SAFETY ALERT #0013 Page 1 of 5

SUBJECT: HW Front Seat Recline Stopper

MODELS AFFECTED: <u>Factory built aircraft:</u>

Figure 2: Obsolete Assembly Instructions (Detailed)

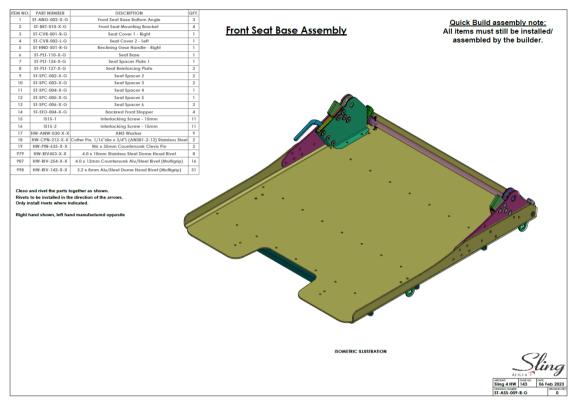
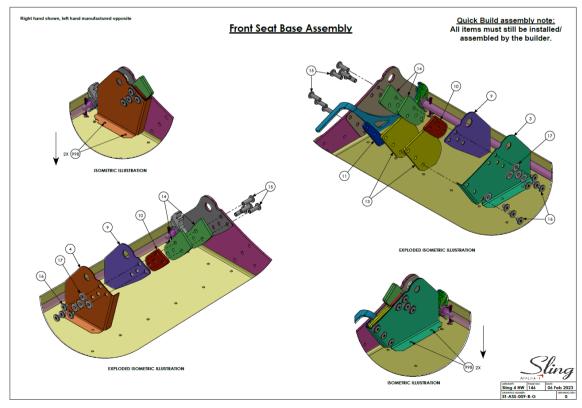
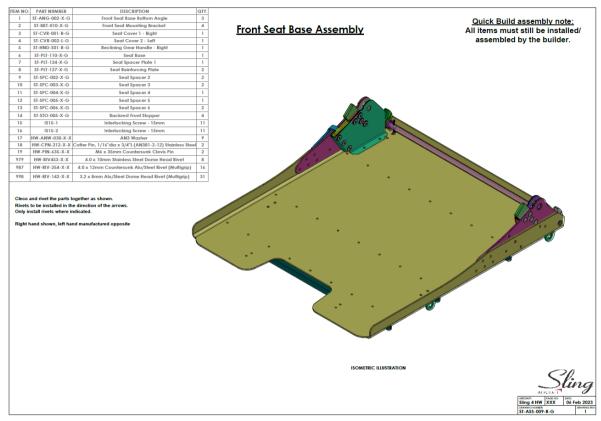
This Safety Alert introduces a modification that limits the rearward travel of the pilot and co-pilot seat backrests. The modification enhances flight safety by ensuring that, in the event of a seat recline mechanism failure, both occupants retain proper seating position and maintain effective control of the aircraft.

At present, Sling does not deem a complete redesign of the seat recline mechanism necessary. However, the installation of a permanent stop limiting the seat recline to the third adjustable position is required to effectively mitigate the risk.

- Step 2: Using a Phillips screwdriver, remove the screws (Item 15 & 16) on both sides of the seat as shown in Figure 2.
- Step 3: Also remove items 10 (qty 2), 11 (qty 1), 13 (qty 2), and 14 (qty 4), as shown in Figure 2.

Step 4: Install the new backrest stopper plates (revised Item 14) with the previously removed Items 10, 11 and 13 as shown in Figure 4.

Step 5: Reinstall and securely tighten all screws (item 15 & 16). Use Loctite 243 (blue) to secure
